**Economic and Social Council**Distr.: General
8 August 2019

Economic Commission for Europe**Inland Transport Committee****World Forum for Harmonization of Vehicle Regulations****Working Party on Lighting and Light-Signalling****Eighty-second session**

Simplification of lighting and light-signalling UN Regulations**Proposal to correct UN Regulation No. [148] (Light Signalling Devices)****Submitted by the Informal Working Group on Simplification of Lighting and Light-Signalling Regulations (IWG SLR)***

“Figure A3-I:
Standard light distribution for front and rear position-, parking-, end-outline marker-, stop- and direction indicator lamps

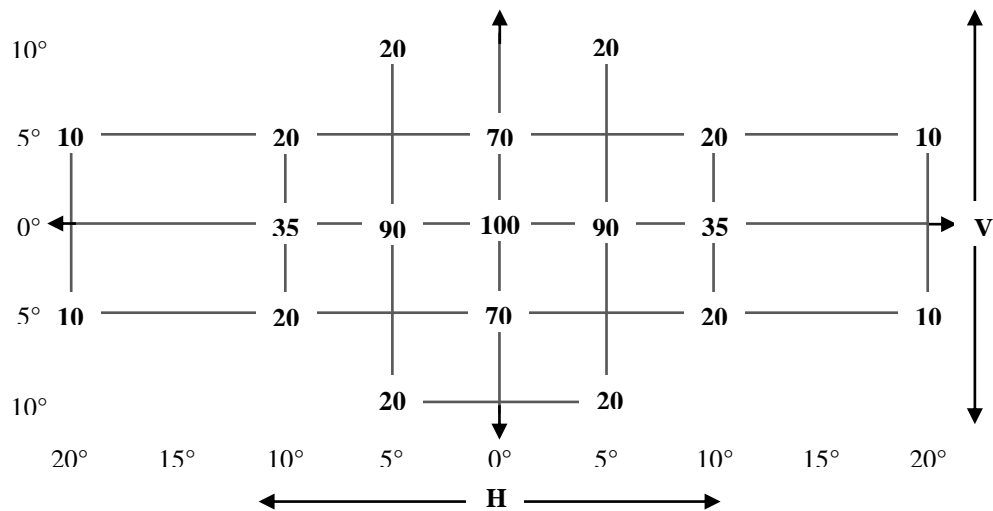
Annex 3, paragraph 2.1., figure A3-I, replace the existing figure to read:

1. In table 9, the reference to note 1 is a typo which should be deleted.
2. In the English version of document ECE/TRANS/WP.29/2018/157, figure A3-I contains additional characters that should be removed.
